ATTACHMENTS FOR: AGENDA NO. 8/24 COUNCIL MEETING

Meeting Date: Tuesday 28 May 2024
Location: Council Chambers, Level 1A, 1 Pope Street, Ryde and Online
Time: 6.00pm

Item		Page
16	TRAFFIC AND PARKING MATTERS APPROVED BY THE RYDE TRAFFIC COMMITTEE MEETING - APRIL 2024	
	Attachment 1 Ryde Traffic Committee Agenda - April 2024	1
	Attachment 2 Draft - Ryde Traffic Committee Meeting Minutes - April 2024	41

Subject:	RYDE TRAFFIC COMMITTEE MEETING – APRIL 2024
Venue:	MS Teams and North Ryde Office, Level 1, Building 0, Riverview Business Park, 3 Richardson Place, North Ryde, 2113 – Meeting Room Landmark
Date:	24 April 2024
Time:	11:00am to 11:25am
Chair:	Mr Muddasir Ilyas
Staff Convenor:	Mr Muddasir Ilyas
Meeting Length	25 minutes

Figure 2 – Proposed concept design for pedestrian refuge.

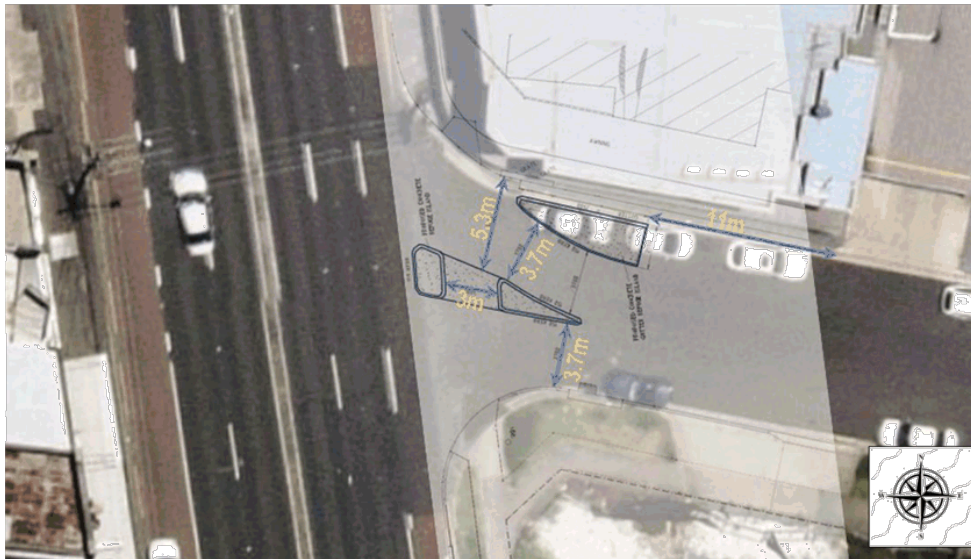
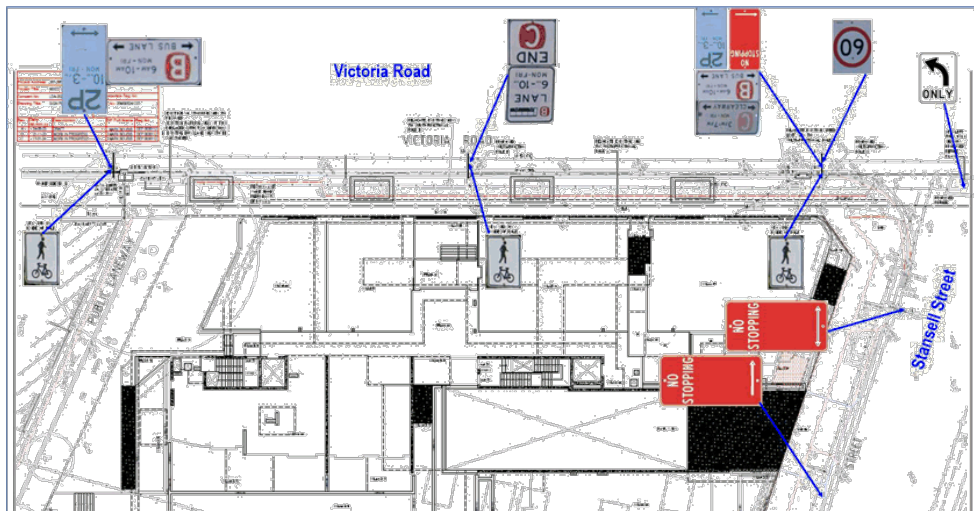
Tanmila has requested to delete recommendation (b) regarding signage on Victoria Road from the report because any changes on Victoria Road do not require approval from the traffic committee. Additionally, Tanmila has requested that the developer submit a swept path analysis and revised plans to TfNSW for approval.
